PLANNING COMMISSION REGULAR TUESDAY, April 9, 2024 at 5:30 P.M. Hybrid Meeting

Planning Commission Regular Meeting
Date Of Planning Commission Meeting: April 9, 2024

ERB Review - Entrance Corridor Design Guidelines - The Verve, 100 Stadium Road, ERB review April 9, 2024

ELEVATION - NORTH

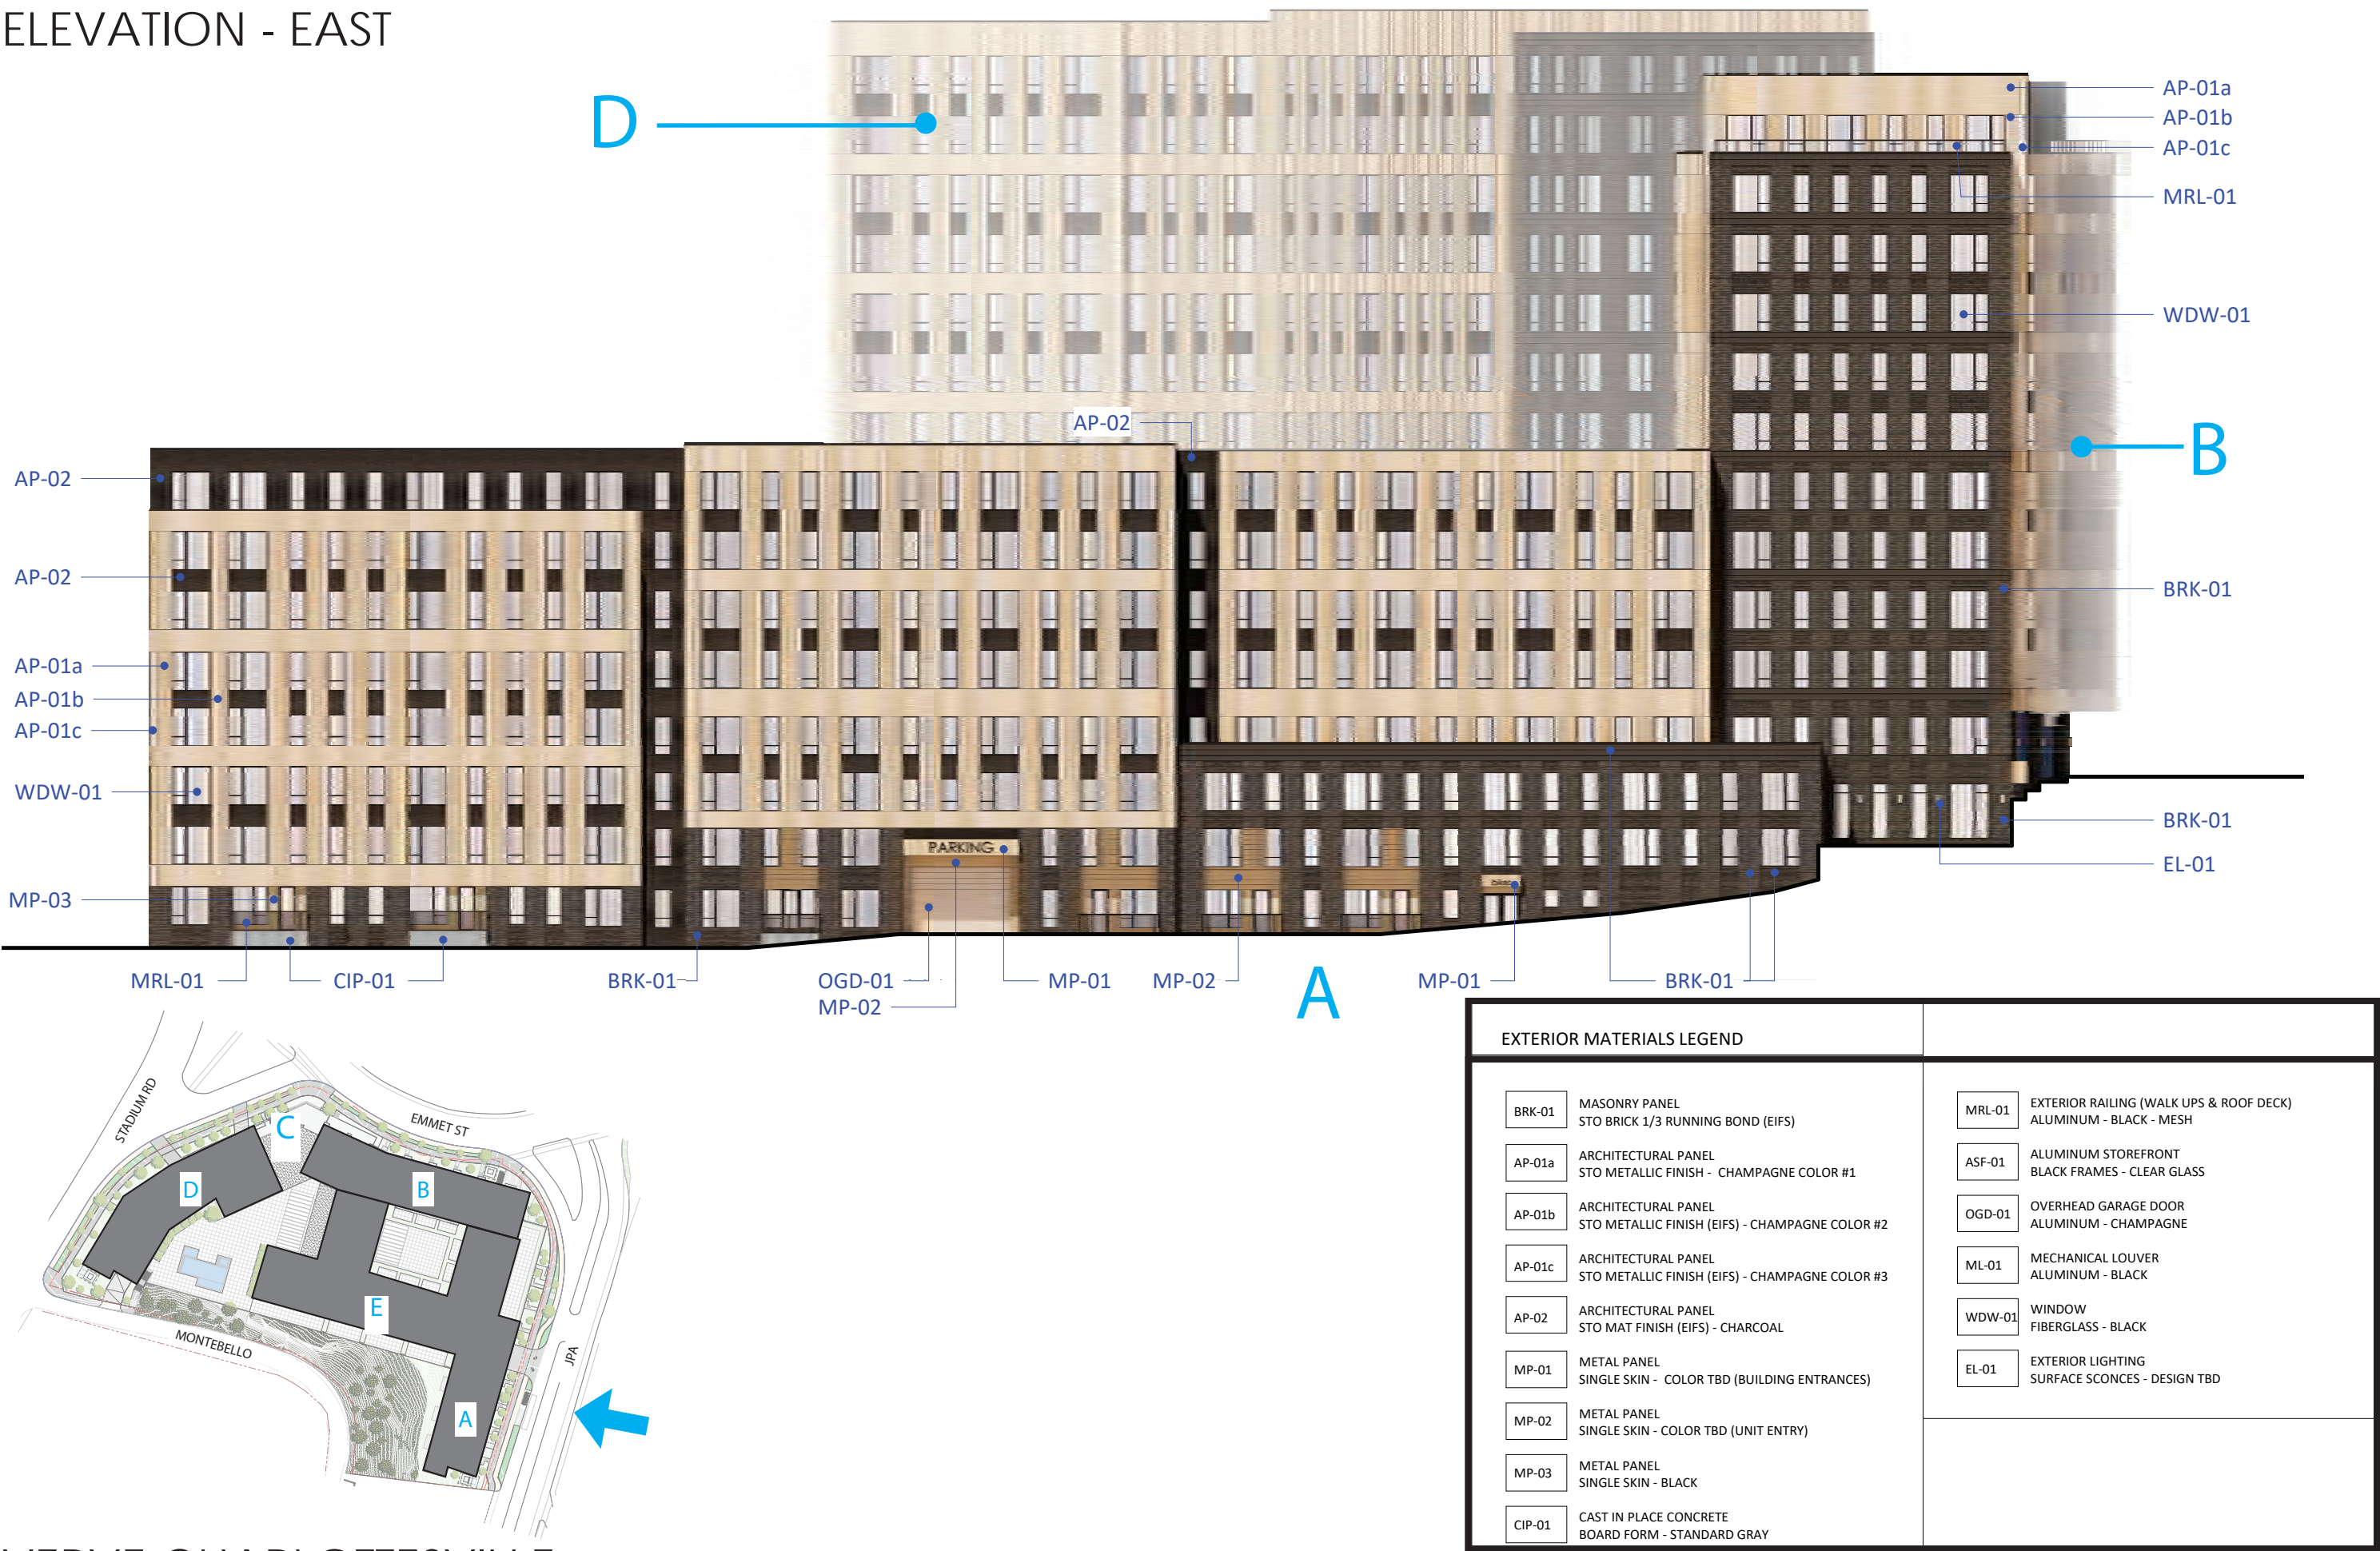
Wall detail: The ERB should discuss the vertical and horizontal lines of the EIFS panels, as indicated in the renderings (see below), and determine if there is a preference for the detail to be flush (flat with the wall) or proud (projecting from it, framing the EIFS panels), or some combination of both. The applicant expressed that this detail is not finalized, that the intent of illustrating the lines in the renderings was to communicate the *overall pattern of jointing* and the *mixture of the three tones of champagne colors*.

The guidelines do not recommend one or the other, only broadly suggesting that materials and elements offer texture and visual interest. The guidelines for details suggest the use of articulated elements and variations in the wall plane. The ERB should determine if those recommendations are achieved satisfactorily by other elements of this design, thus allowing flexibility to finalize this detail later, or if this detail must be clarified prior to approval of a CoA.

- [EIFS] (*Clarification of the joint detail.*)
